PLANT NAME:
Nine Mile Point #2

Furnishing requested information regarding the revetment ditch system for Unit No. 2.

Re: Nine Mile Point Unit 2
Docket No. 50-410

Enclosed is information requested in your July 16, 1976 letter regarding the revetment ditch system for Nine Mile Point Unit 2. Five copies of this information are provided which responds to your questions 1, 2, 4, 5 and 6. Information responding to questions 3 and 7 will be submitted about September 28, 1976.

FIGURE 1
LAKE ONTARIO COMPUTATION GRID
AND BOTTOM DEPTHS
NINE MILE POINT NUCLEAR STATION-UNIT 2
NIAGARA MOHAWK POWER CORPORATION

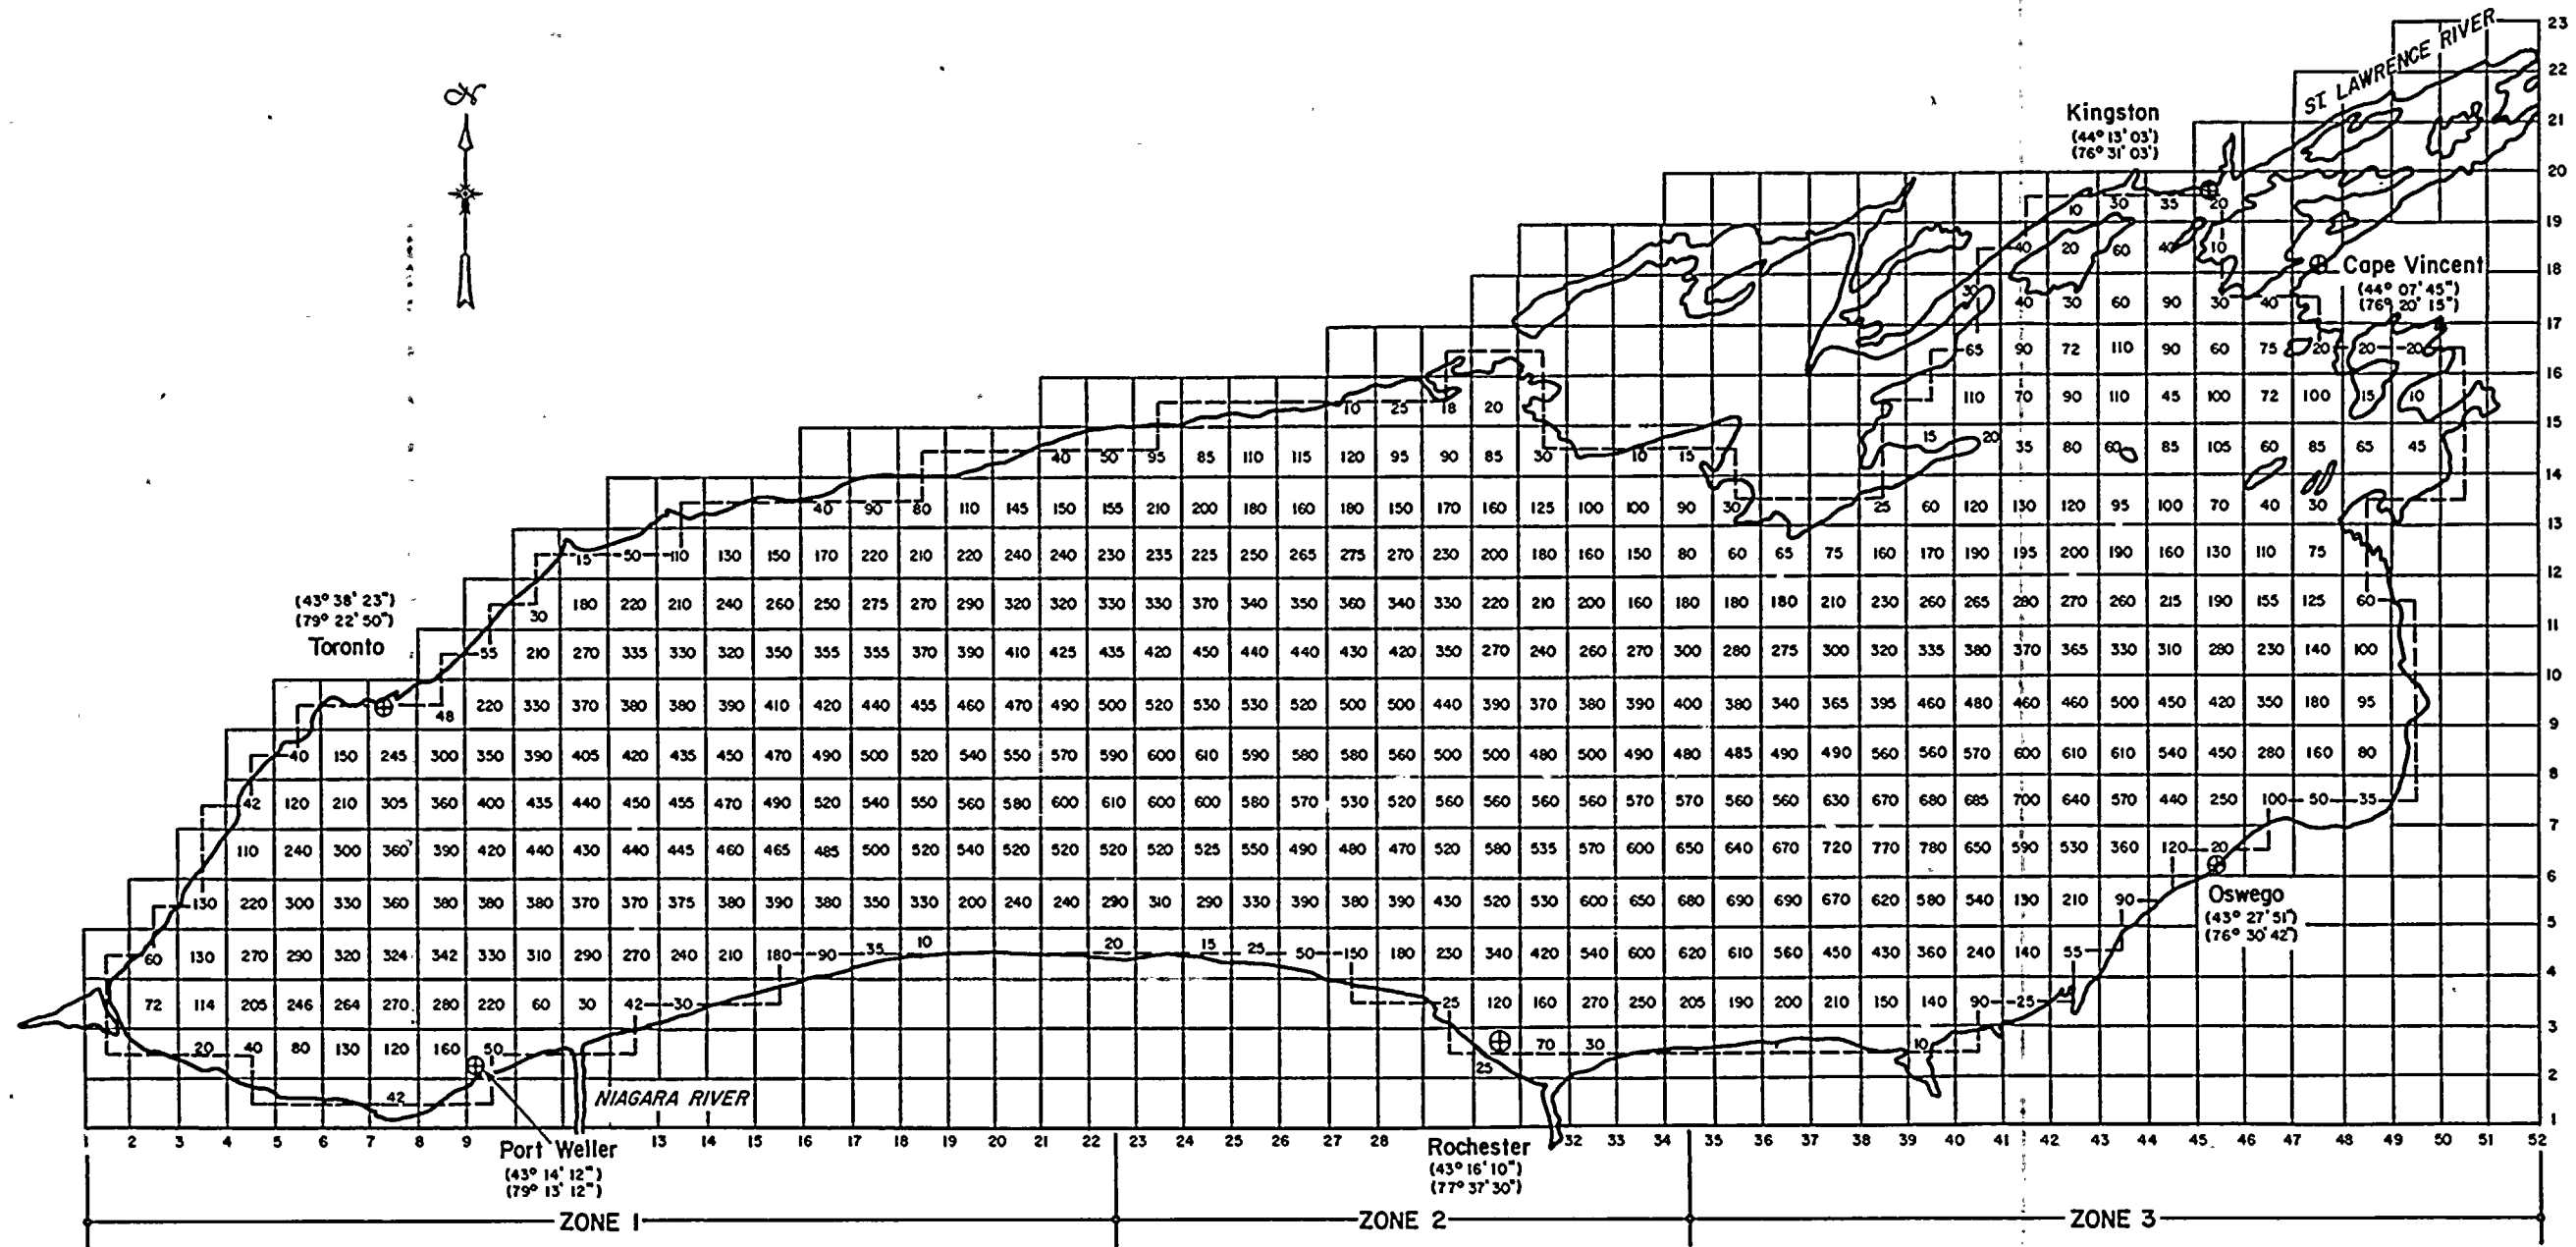
The verification studies are inconclusive in defining the accuracy to which the model can predict storm surge. In addition to fluctuations in the predicted surge hydrographs, that in many cases are very different from that recorded, extreme values are seen to differ by tens of percent in several cases. In particular, the model underpredicts the surge at Oswego (the only verification gage station near the site) from the February, 1972, storm by over 15 percent. It is our position that either the model be revised to conservatively reproduce historical storm surges or criteria be developed to increase predicted extreme surge values to produce conservative results.

In addition, for verification studies include maps locating gage stations and grid points and depths where the surge was calculated.

Figures 1 and 2 show the computation grid, water depths and actual verification gage locations for Lakes Ontario and Erie, respectively. In the verification studies, the grid points nearest to the actual gage stations were selected and the calculated surges at these points were compared to the recorded surges at the gage stations. Tables 1 and 2 list gage stations, verification grid points, and water depths at each grid point for Lake Ontario and Lake Erie.

The grid point selected for the plant site is (47,8). The average water depth is computed by averaging the water in the grids surrounding the grid point. This is the most representative model grid location of the site with an average water depth of about 93 feet as shown in Figure 1.
